MEMORANDUM

SUBJECT: Upper Des Plaines River Watershed Impact Study
(CBBEL Project 180245)

This memorandum summarizes our technical evaluation of the wetland, stormwater and floodplain components of the Foxconn Development in Kenosha County, Racine County and the Village of Mount Pleasant, WI. A full list of the extensive data set reviewed for this analysis is provided in Appendix 1.

Figure 1. Wisconsin Valley Way Typical Section (Source WisDOT Public Exhibit – 3/15/18)

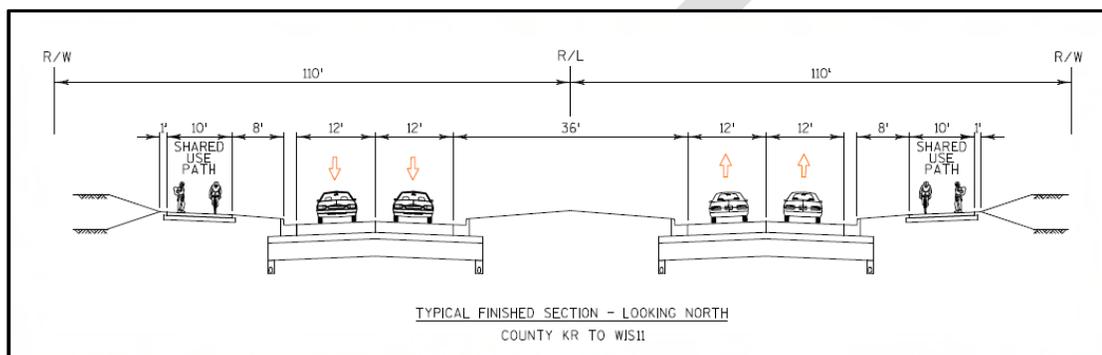
- a. Wisconsin Valley Way:
 - i. Proposed Typical ROW width = 220 ft.
 - ii. Typical width of disturbance on plans = 170 ft.
 - iii. Approximate width included in Stormwater Report Exhibit = 130 ft.
- b. County Road KR:
 - i. Proposed Typical ROW width = 224 ft.
 - ii. Typical width of disturbance on plans = 200 ft.
 - iii. Approximate width included in Stormwater Report Exhibit = 180 ft.

Review of the construction plan cross-sections indicated that proposed drainage areas in the report may be less than the total developed areas within the ROW. Given the scale of the drainage report exhibits and draft nature of the stormwater report, this is an area that may require further investigation/clarification.
